# UNITED STATES PATENT AND TRADEMARK OFFICE

10/575,507

| <b>Office Action Summary</b> | <b>Application No.</b><br>10/575,507 | <b>Applicant(s)</b><br>GRASMUCK, GILBERT |  |

## **DETAILED ACTION**

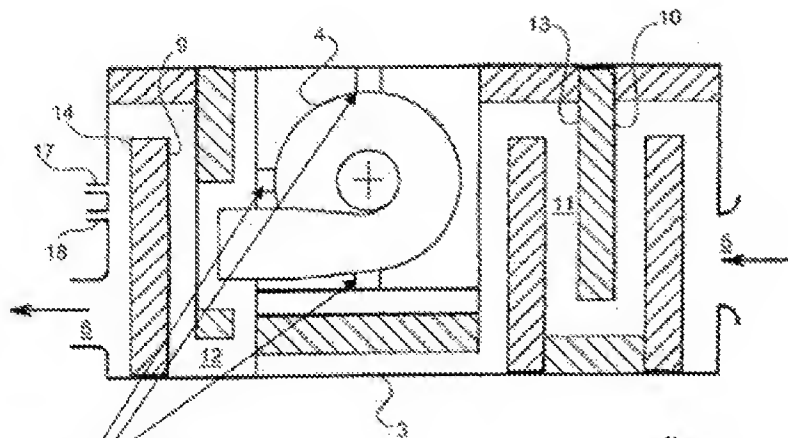
The drawings are objected to under 37 CFR 1.83(a). The drawings must show every feature of the invention specified in the claims. Therefore, the flexible element intercalated between said volute and dynamic assembly (claim 4) (see annotated Figs. below), intermediary of an impervious material (claim 10), sensors for detecting angular position (claim 13), motor with permanent magnets at a rotor under electronic means (claim 14), and a single volute covering several wheels (claim 17) must be shown or the feature(s) canceled from the claim(s). No new matter should be entered.

Corrected drawing sheets in compliance with 37 CFR 1.121(d) are required in reply to the Office action to avoid abandonment of the application. Any amended replacement drawing sheet should include all of the figures appearing on the immediate prior version of the sheet, even if only one figure is being amended. The figure or figure

fig. 1

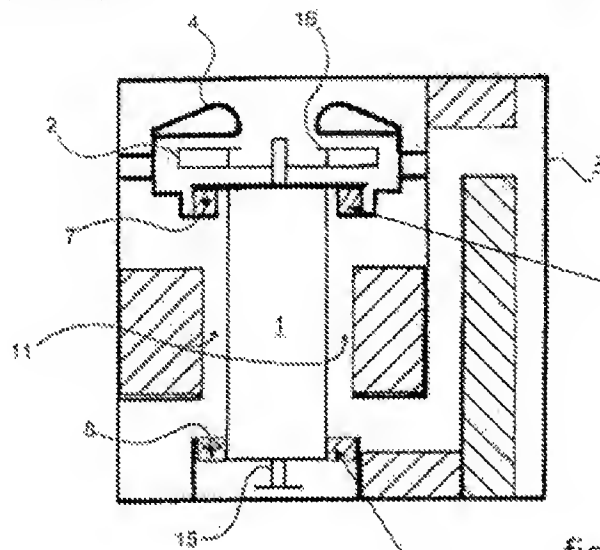
The drawings are objected to because a) what appear to be connections or fittings between the volute and the casing are unlabeled (see annotated Figs. below, page 9, para [0042] for discussion); b) the hash marks indicating elastomer material are inconsistent; and c) it is unclear what cross section of Fig. 1 is being presented in Fig. 2 (top view? top view rotated? side view?). Corrected drawing sheets in compliance with 37 CFR 1.121(d) are required in reply to the Office action to avoid abandonment of the application. Any amended replacement drawing sheet should include all of the figures appearing on the immediate prior version of the sheet, even if only one figure is being amended. The figure or figure number of an amended drawing should not be labeled as “amended.” If a drawing figure is to be canceled, the appropriate figure must be removed from the replacement sheet, and where necessary, the remaining figures must be renumbered and appropriate changes made to the brief description of the several

What is this?

Elastomer not  
shown connected to  
"dynamic assembly"

Hash marks different than "8"

views of the drawings for consistency. Additional replacement sheets may be necessary to show the renumbering of the remaining figures. Each drawing sheet submitted after the filing date of an application must be labeled in the top margin as either "Replacement Sheet" or "New Sheet" pursuant to 37 CFR 1.121(d). If the changes are not accepted by the examiner, the applicant will be notified and informed of any required corrective action in the next Office action. The objection to the drawings will not be held in abeyance.

(modified)  
**Fig. 3**

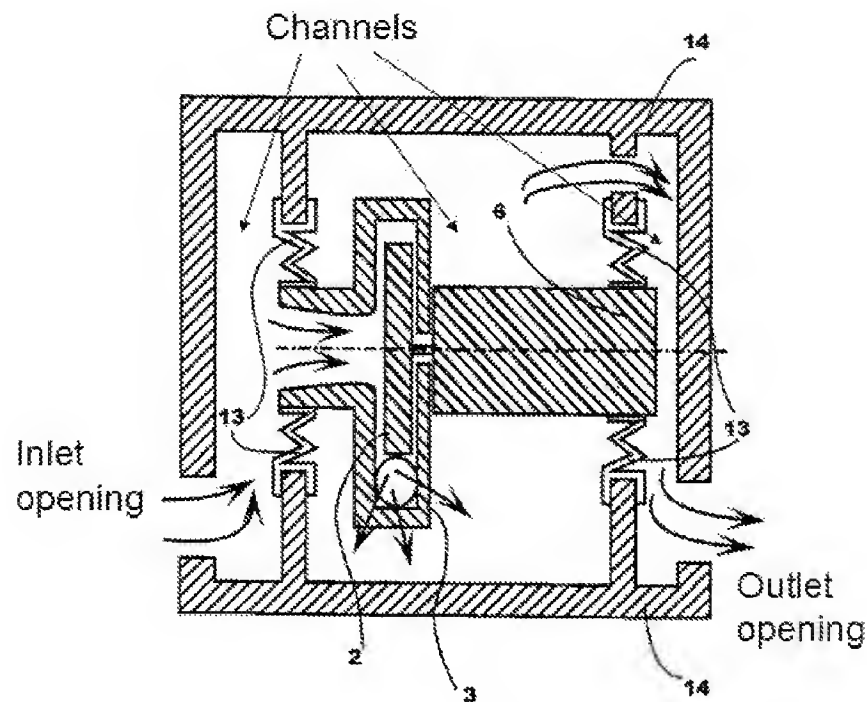
channels circulating a gaseous flux, said channels being arranged inside said casing upstream and downstream of the ventilator (Fig. 3 modified, below), induction and discharge of said gaseous flux through openings of said casing for intake and expulsion respectively, said volute being an integral part of said casing (closed capsule 14 formed in part by the housing 3, column 5, line 13) so as to form an integral fixed assembly; and

Regarding claim 8, Hansmann discloses the device as per claim 1, wherein Hansmann further discloses at least one channel is arranged around the driver (see Fig. 3 modified, above), cooling said driver through a passage of gaseous flow in proximity of said driver.

Regarding claim 9, Hansmann discloses the device as per claim 1, wherein Hansmann further discloses at least one channel is organized in the form of a baffle (Fig. 3 modified, above).
